# Sub Regional RTEP Committee PJM West

April 23, 2019

## B2761.1 – Scope Clarification /Cost Update

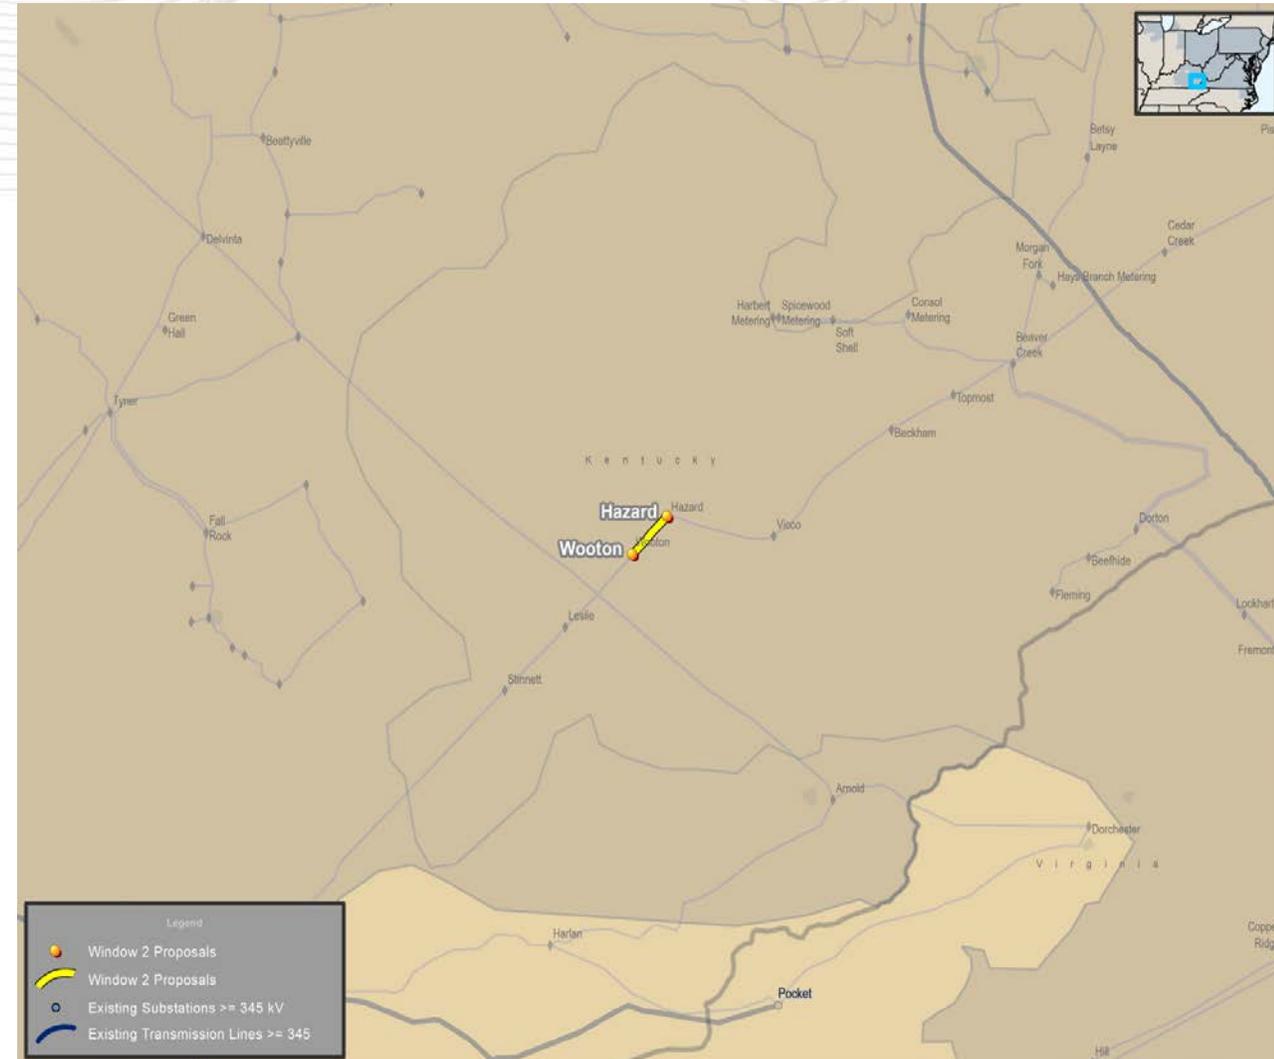
**Original Scope Description:** Replace the Hazard 161/138 kV Transformer

**Original Estimated Cost: \$2.3 M**

**New Scope Description:** Replace **and relocate** the Hazard 161/138 kV Transformer **and circuit breaker 'M'**. Upgrade protection scheme on the new Transformer including installation of low side breaker.

**New Estimated Cost: \$ 3.8 M**

**B2761.3 –Scope Clarification/Cost Update**  
**Previously Presented: 9/11/2017 SR RTEP**

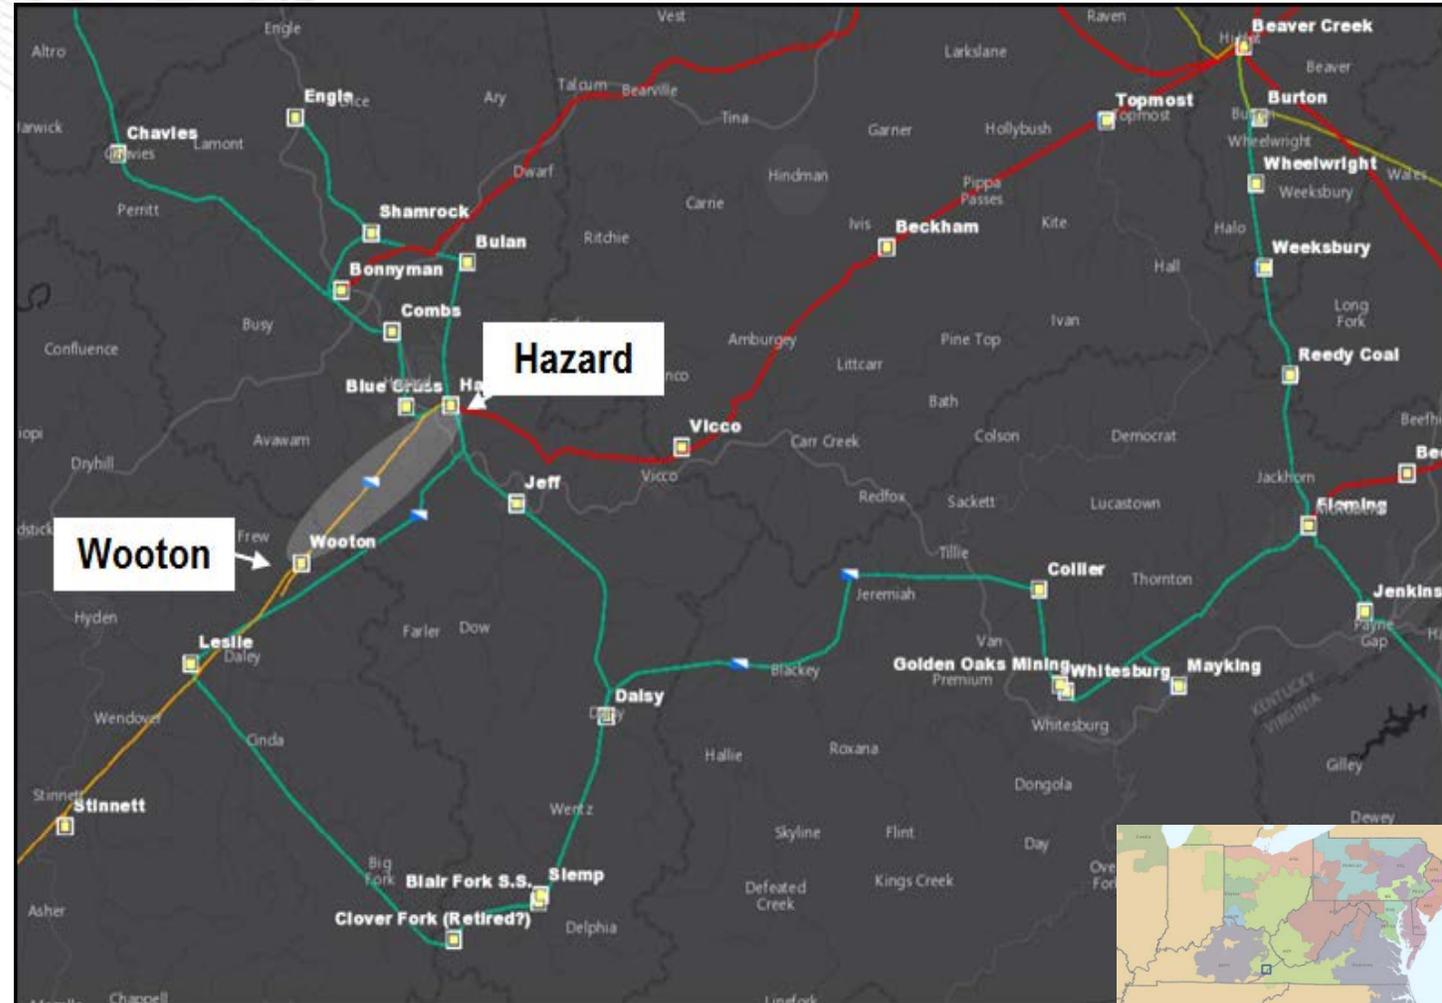
**Original Scope Description:** Rebuild the Hazard – Wooton 161 kV line utilizing 795 26/7 ACSR conductor (300 MVA rating).

**Original Estimated Cost: \$16.48 M**

**New Scope Description:** Rebuild the Hazard – Wooton 161 kV line utilizing 795 26/7 ACSR conductor (300 MVA rating). **Replace line relaying and associated termination equipment .**

**New Estimated Cost: \$16.8 M**
